UNITED STATES PATENT AND TRADEMARK OFFICE

10/580,277

| Office Action Summary | Application No. 10/580,277 | Applicant(s) BONADEI, LUCIA | |

DETAILED ACTION

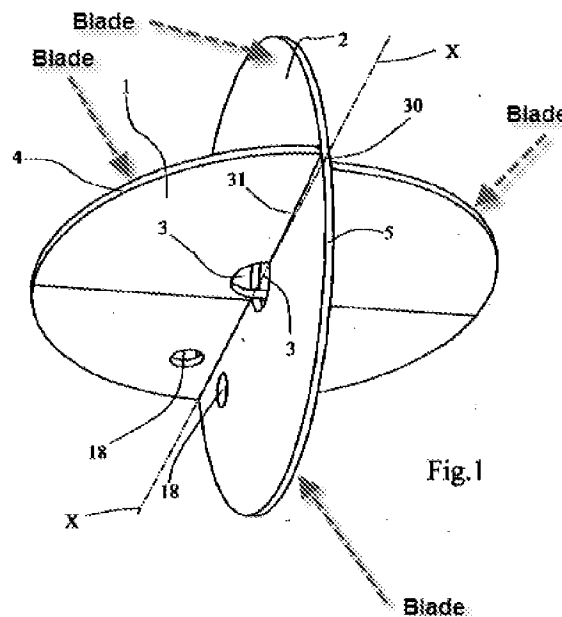
As to **Claim 12**, *Lechot* discloses a surgical reamer (Seen in Fig. 1) comprising at least four flat blades (2 and Fig. 1 below and [0053])

assembled together by means of slots in the blades (plates split down the middle in [0027]), the reamer having a longitudinal axis of symmetry that is coincident with an axis of rotation of the reamer (See Fig. 5), and further wherein at least one of the slots (30) and/or sections of the slot or slots has a different width from that of at least one other slot and/or section of a slot (Slot 30 in disc 1 has different width than slots along middle of plates in [0027]).
